PROPOSAL: Industrial/Warehouse Building  
 LOCATION: Westgate Business Park, Redymant Rd Uthmaniyah  
 APPLICANT: Uthmaniyah Investment Bank Ltd

Report of Dublin Planning Officer dated 4th June, 1991.

**Re: Planning Application For Two Storey Offices With Single Storey Warehouse  
At Westgate Business Park, Ballymount Road, Dublin 12.**

no. 9012 306

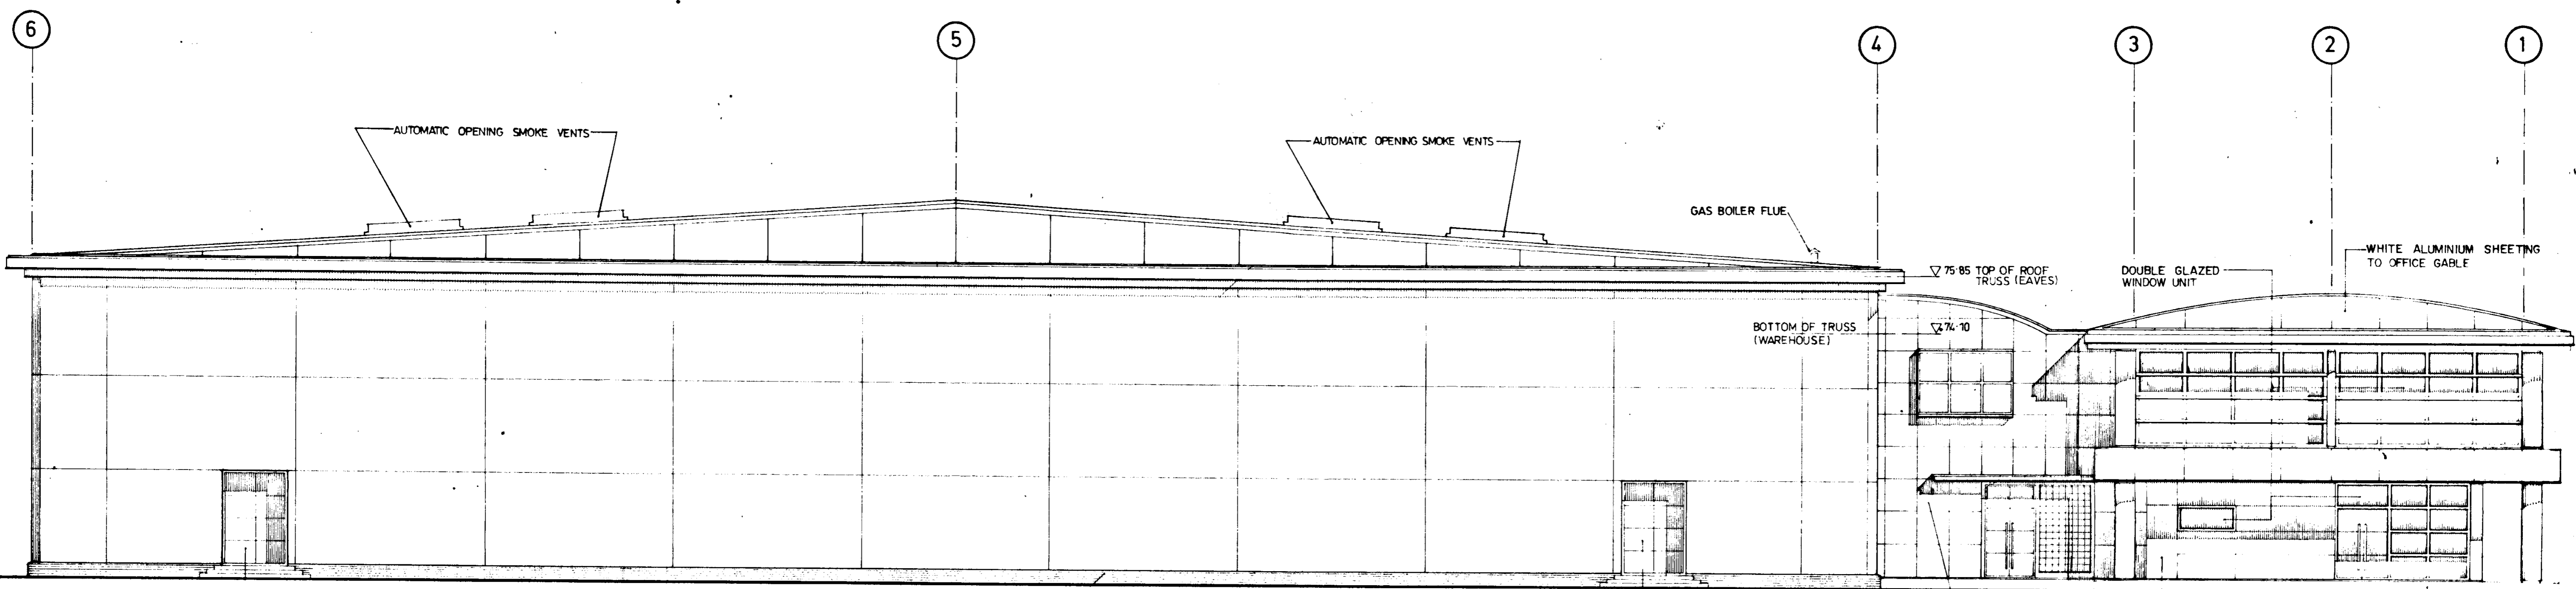
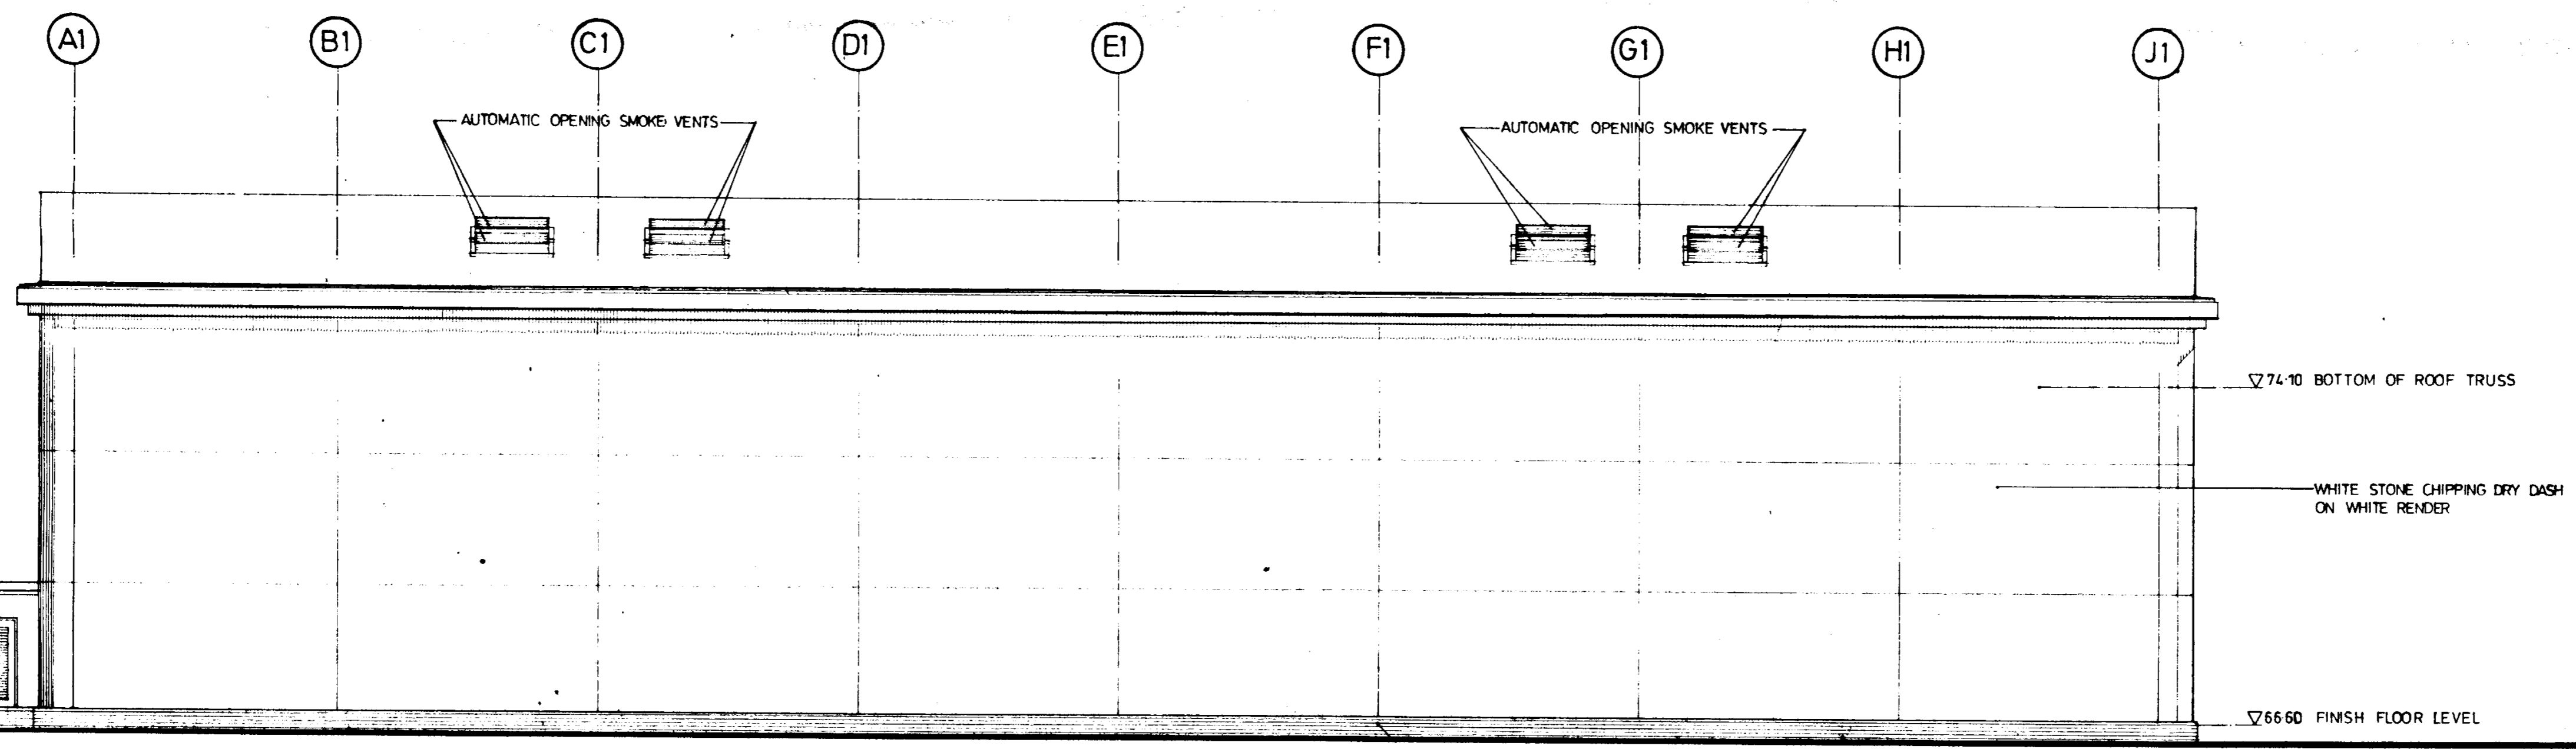
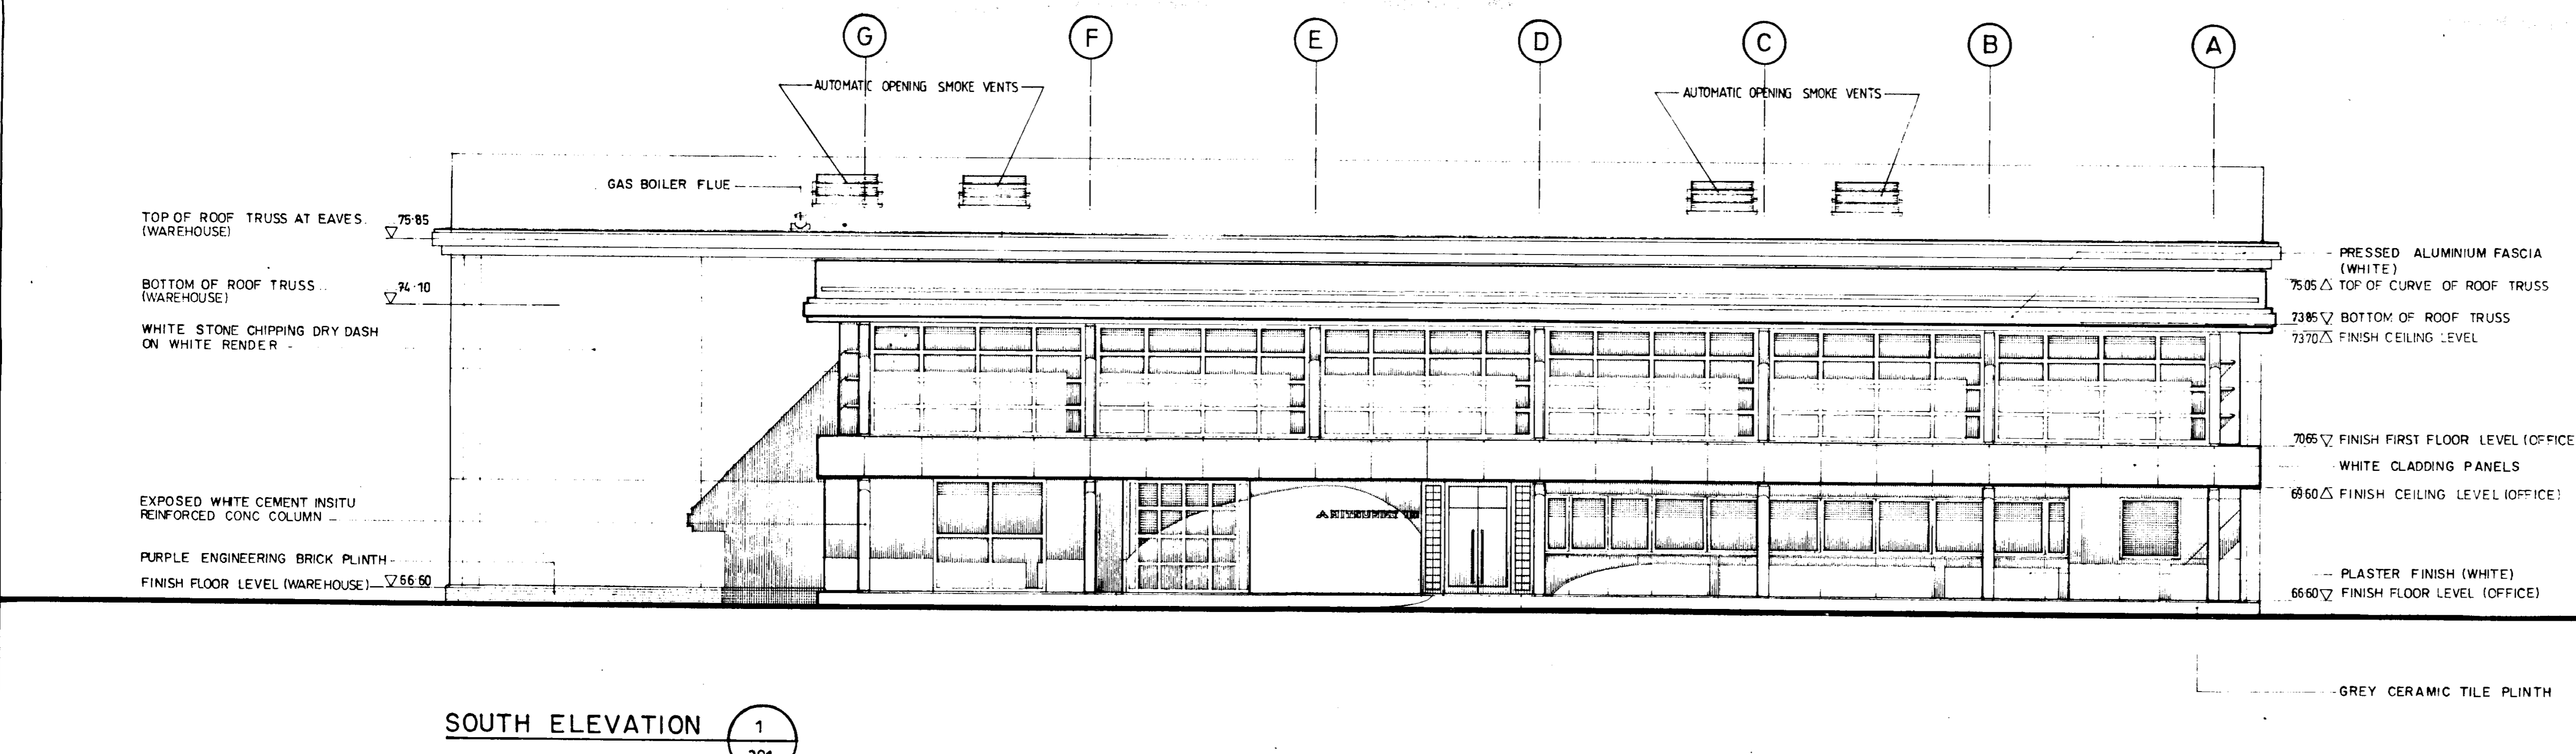
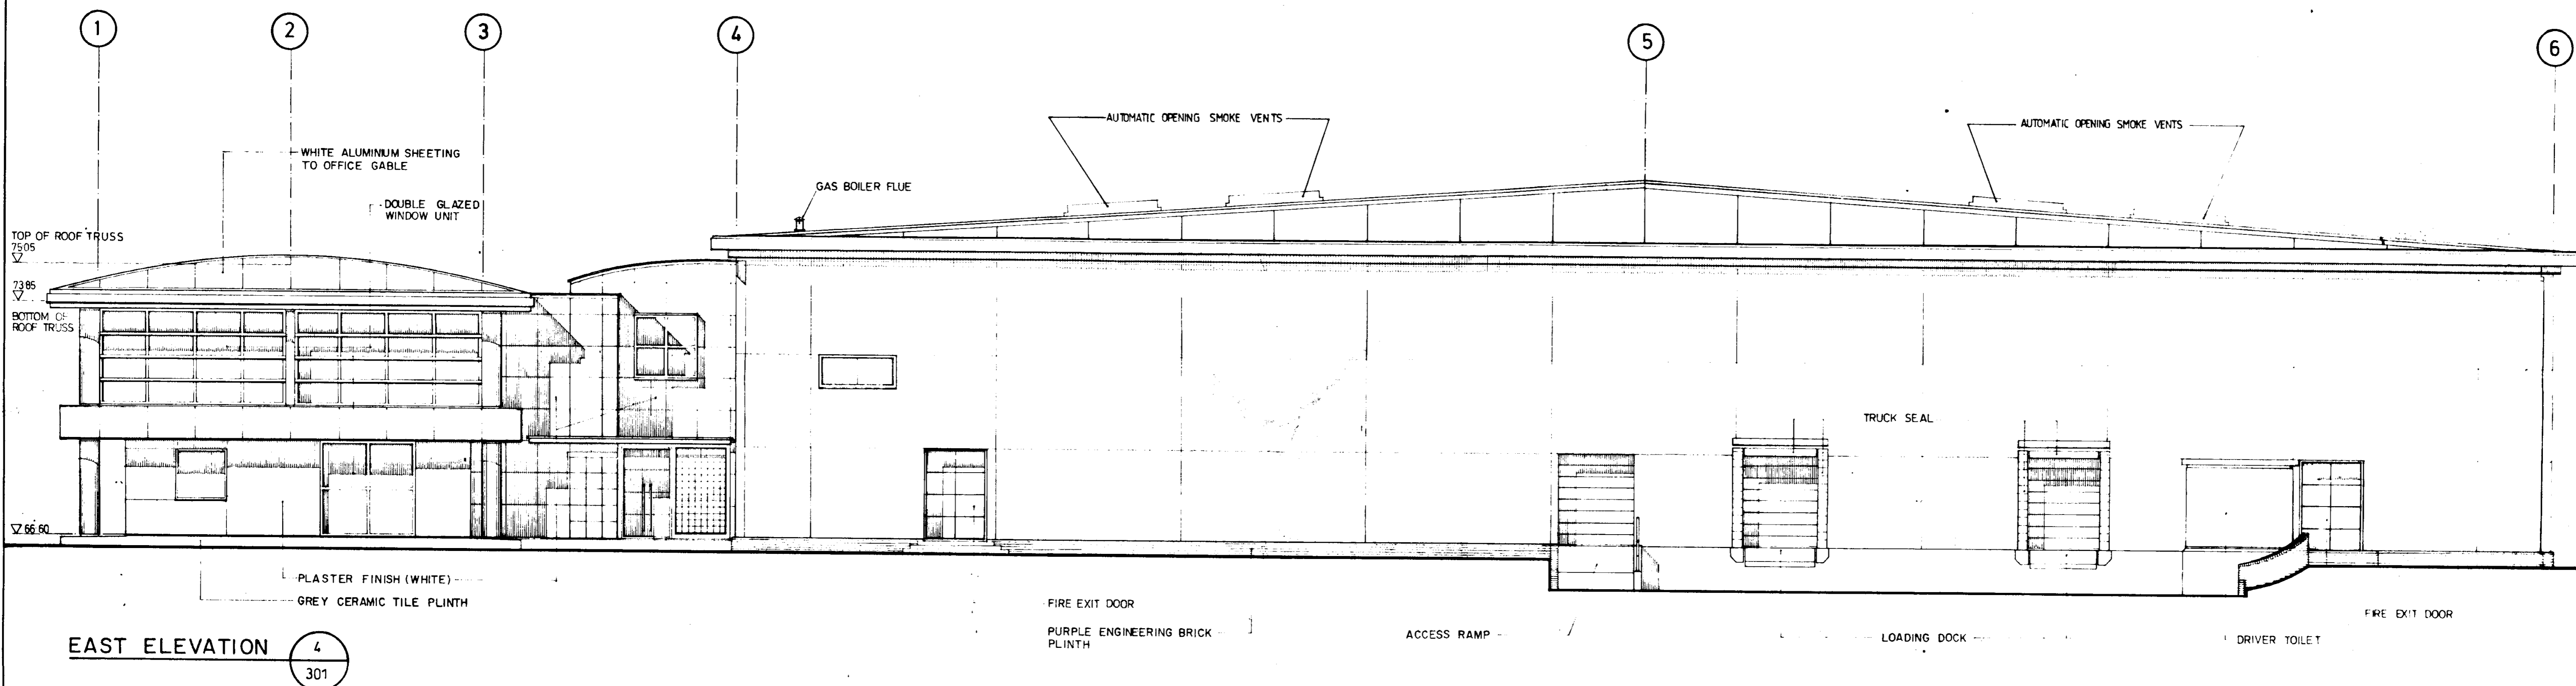
the service / office building. On the Warehouse building the roof is proposed to be clad in a standard metal deck in a grey colour to match the natural aluminium. However while there is no visible change to the outline of the service / office building, the Warehouse roof must be laid to a minimum 4° pitch and cannot be laid to a curve. This causes us to propose a ridge design as drawings no. 9012 306, 9012 307, which slightly alters the profile of the building.
